Prairie Island Nuclear Generating Plant

February 21, 1997 Revision to
License Amendment Request Dated July 28, 1995

Proposed Changes Marked Up
On Existing Technical Specification Pages

Exhibit B consists of existing and new Technical Specification pages with the original proposed changes and all revisions highlighted on those pages. The existing and new pages affected by this License Amendment Request are listed below:

FIGURE TS.5.6-2 Spent Fuel Pool Checkerboard Interface Requirements

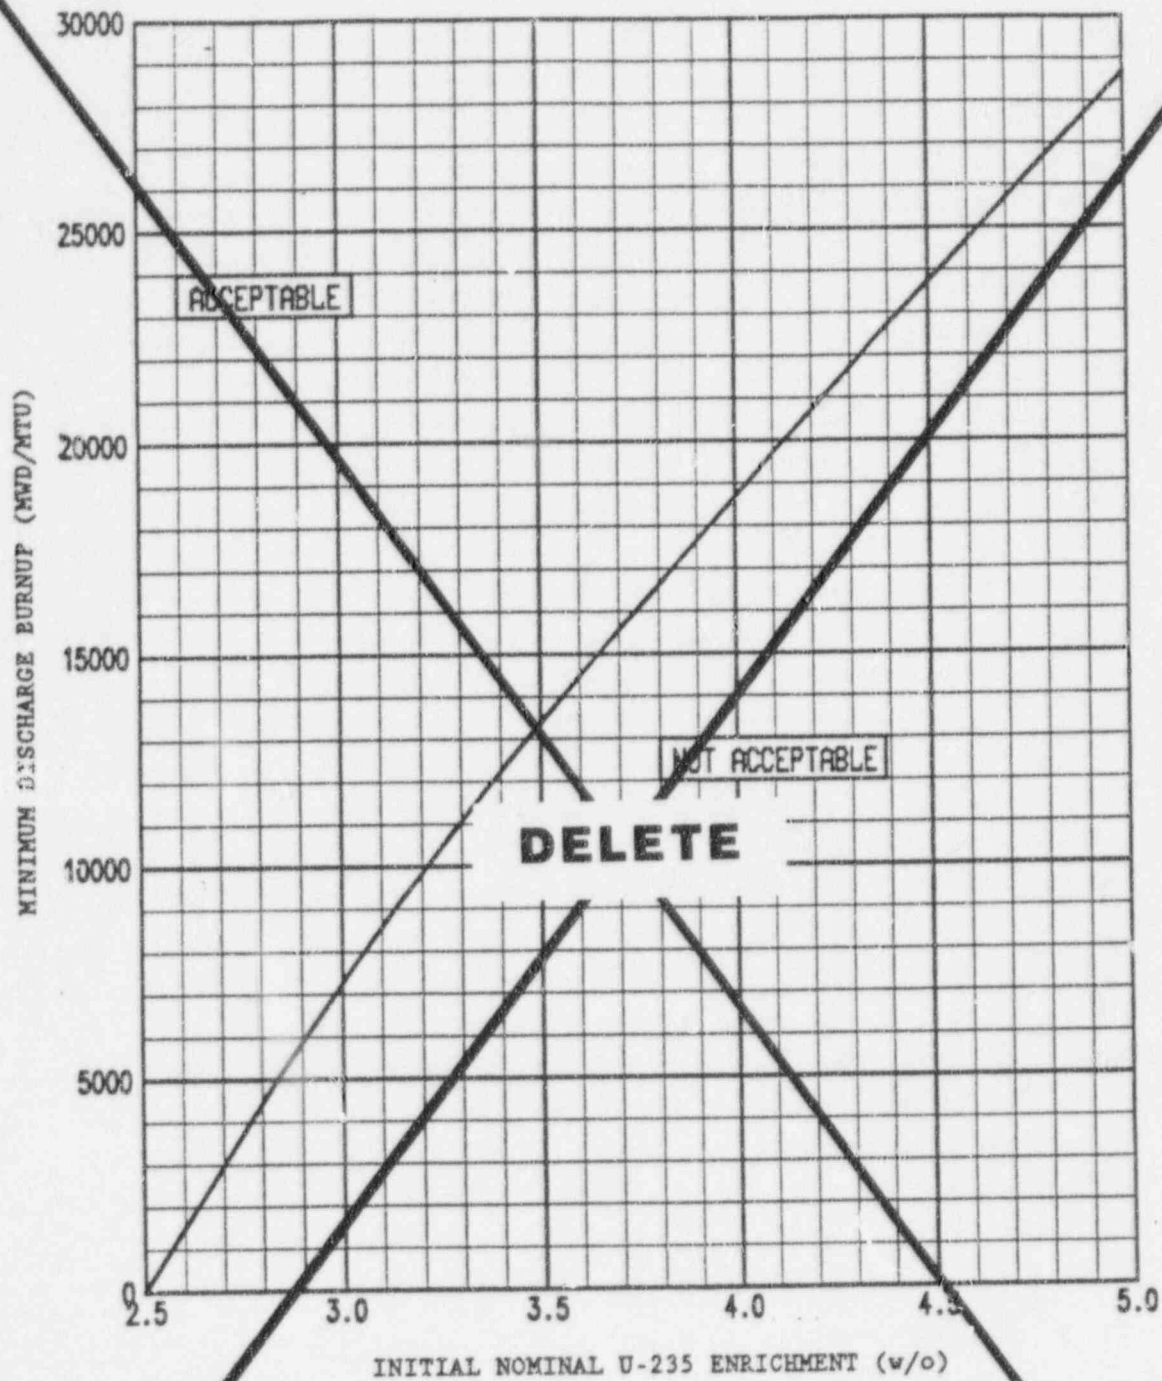
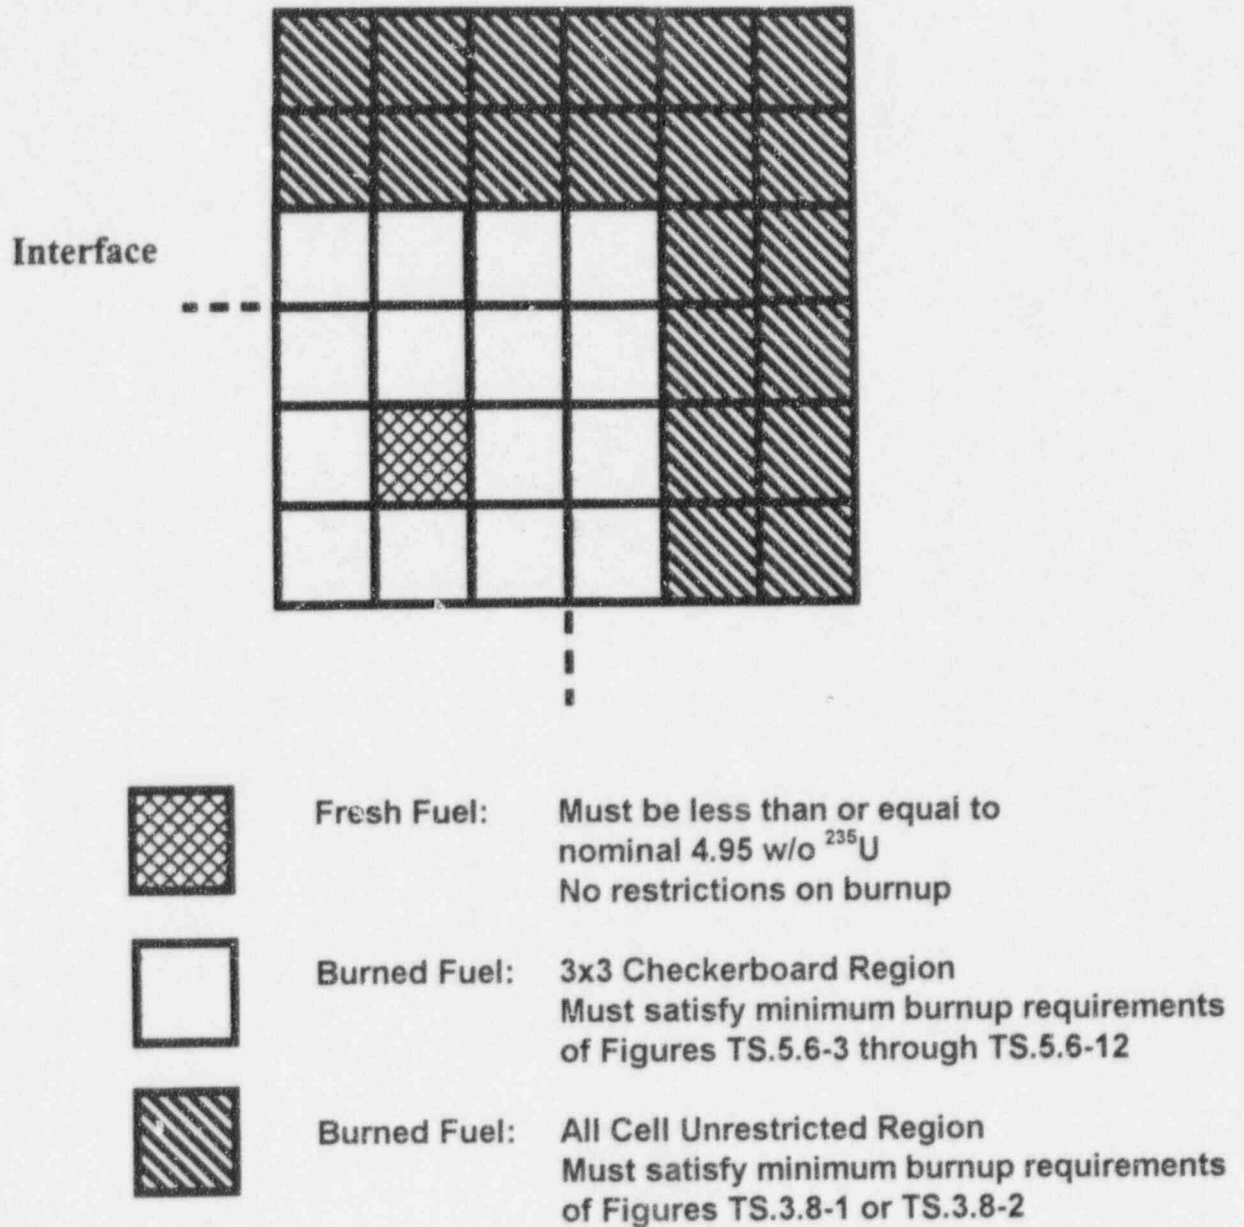
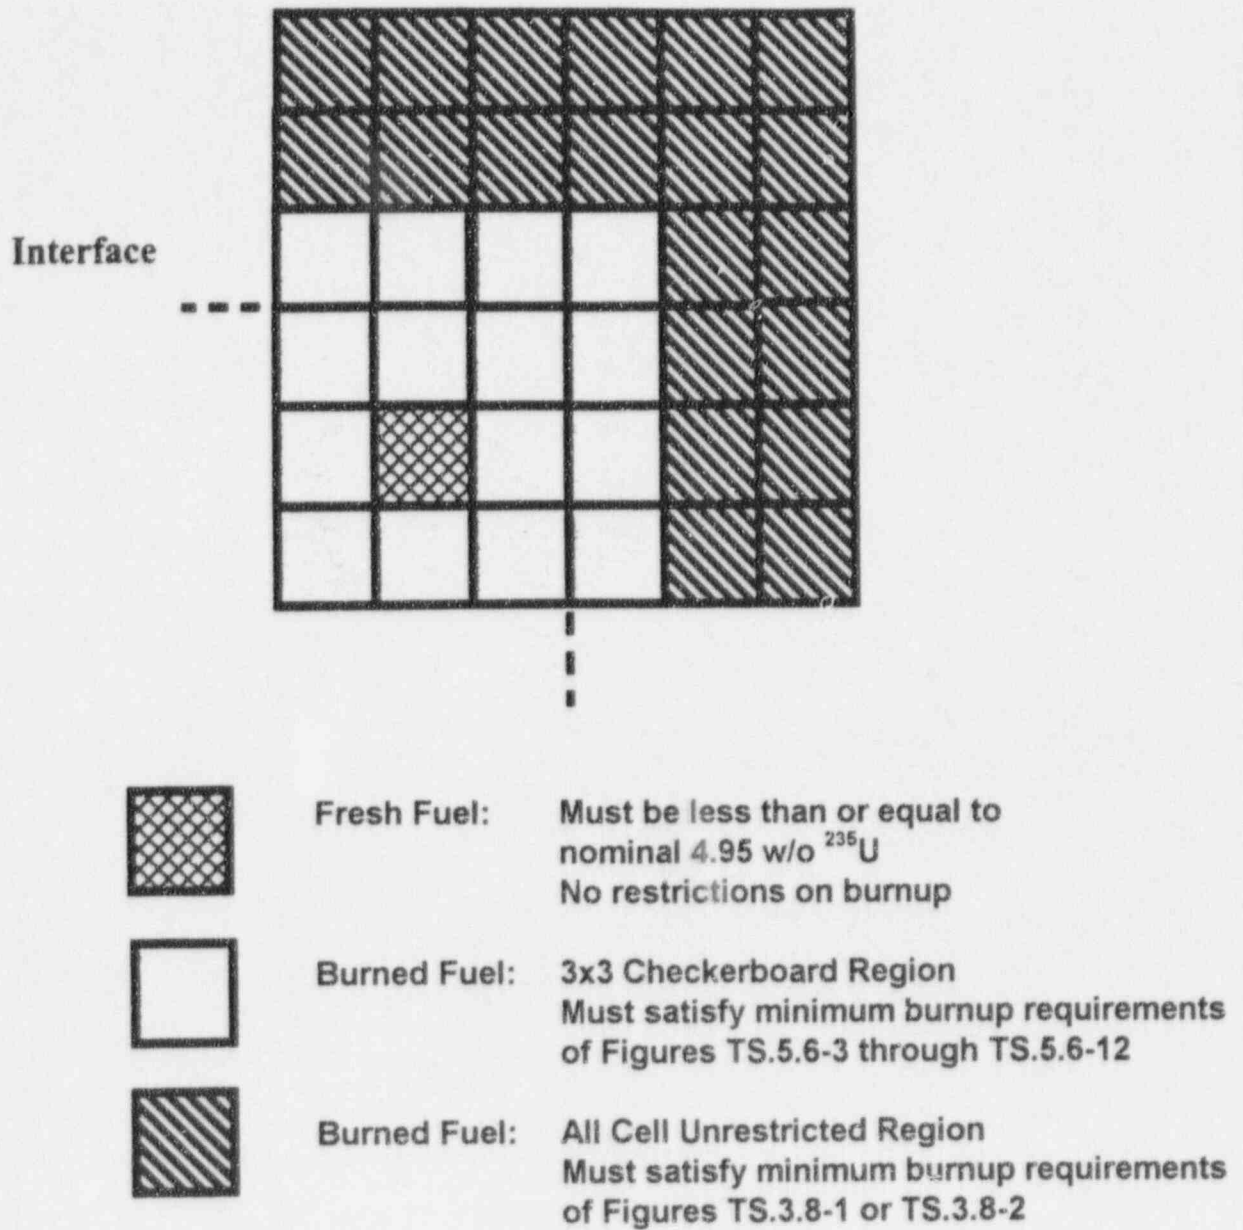
1. separated by a vacant row of cells, or
2. the interface must be configured such that there is one row carryover of the pattern of burned assemblies from the checkerboard region into the first row of the unrestricted region (Figure TS.5.6-12).

1. separated by a vacant row of cells, or
2. the interface must be configured such that there is one row carryover of the pattern of burned assemblies from the checkerboard region into the first row of the unrestricted region (Figure TS.5.6-2).

TS.5.6-3 Spent Fuel Pool Checkerboard Region Burnup and Decay Time Requirements - OFA Fuel, No GAD

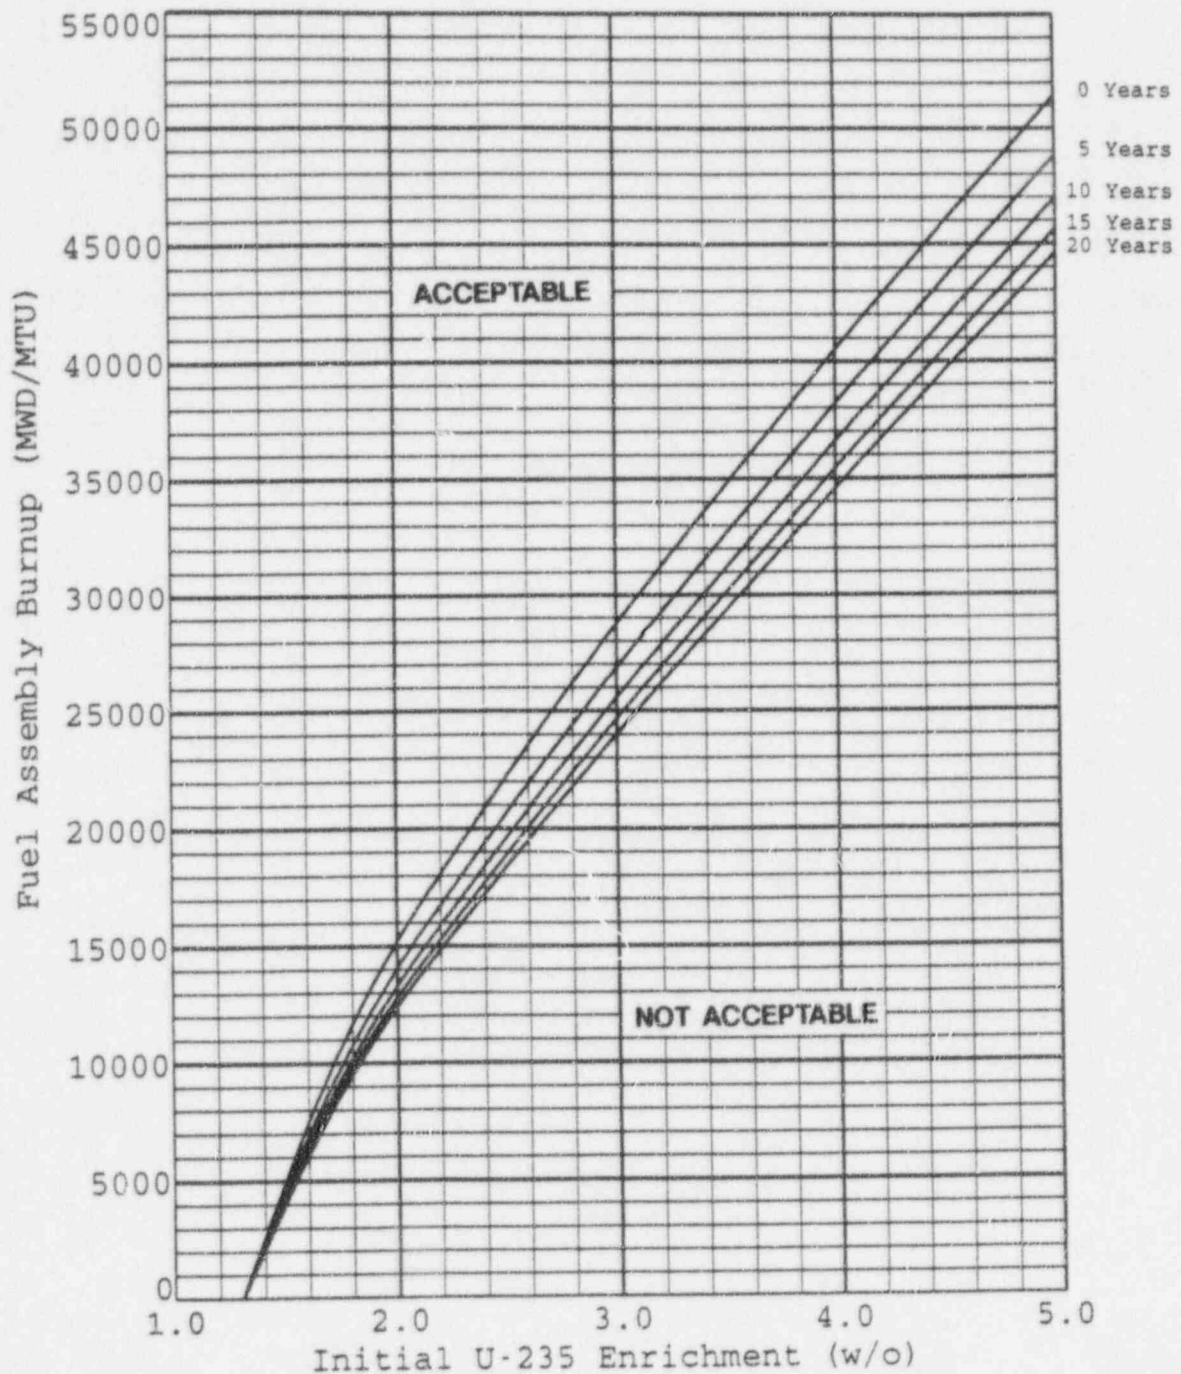
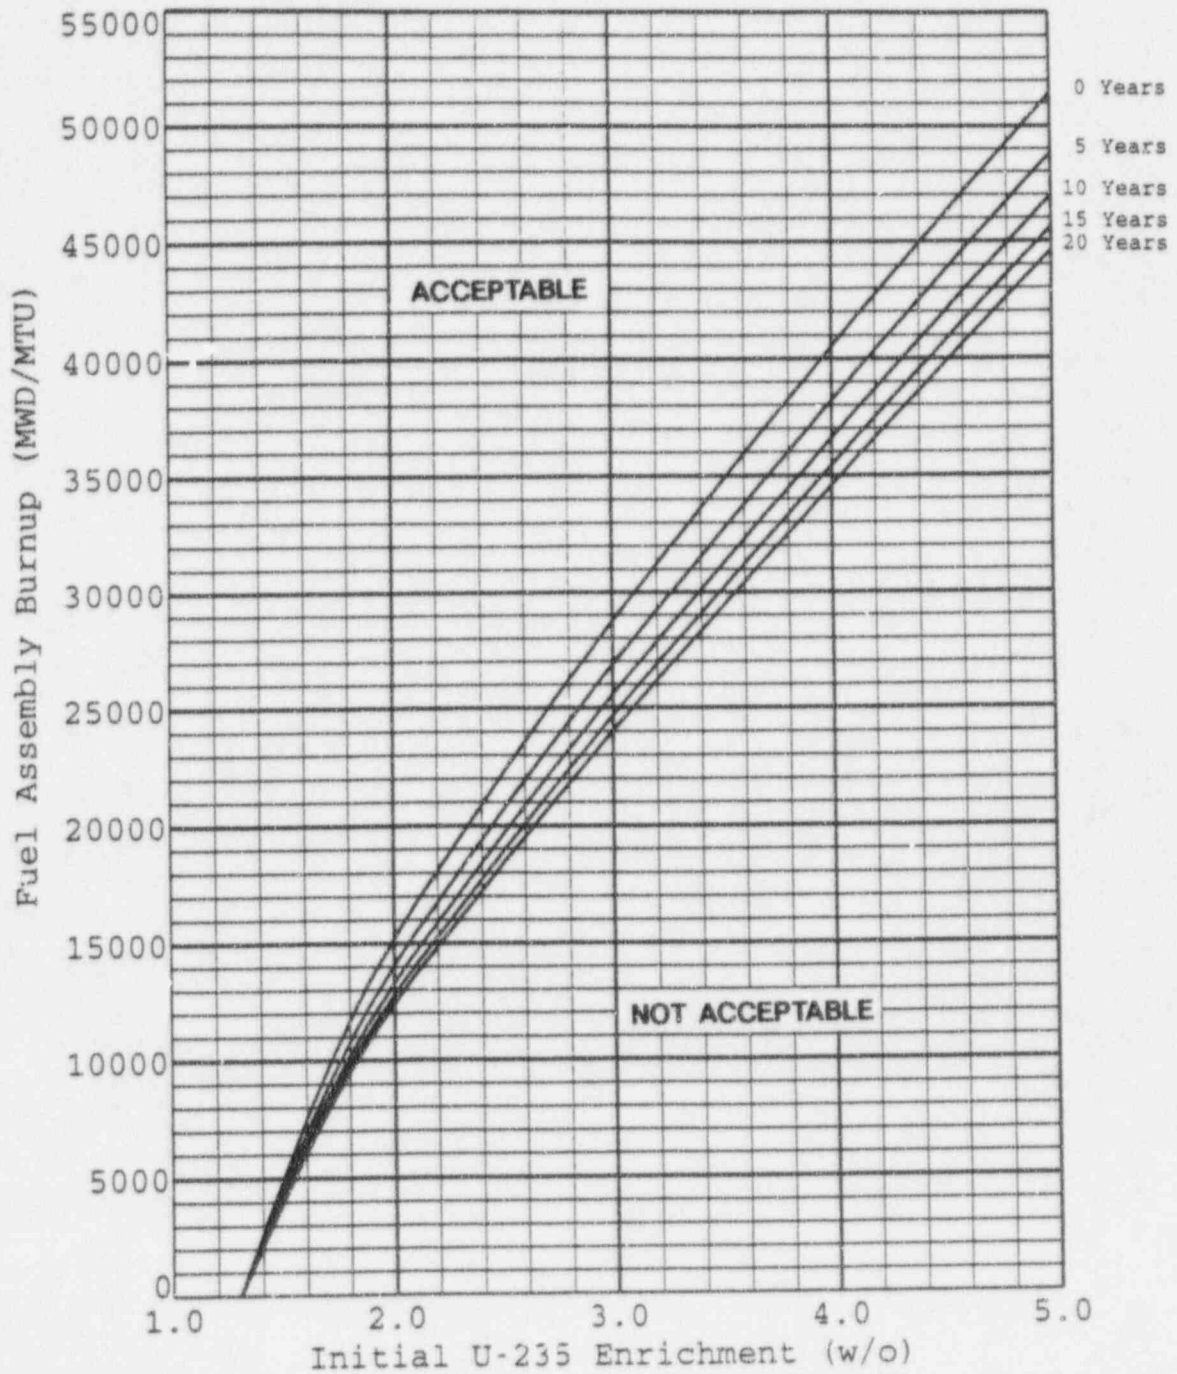
- de. New or spent fuel assemblies with a combination of discharge burnup, ~~and~~ initial enrichment and decay time in the restricted range of Figures TS.3.8-1 or TS.3.8-2, as applicable, will be stored in compliance with Figures TS.5.6-1 ~~and~~ through TS.5.6-212.

- e. New or spent fuel assemblies with a combination of discharge burnup, initial enrichment and decay time in the restricted range of Figures TS.3.8-1 or TS.3.8-2, as applicable, will be stored in compliance with Figures TS.5.6-1 through TS.5.6-12.
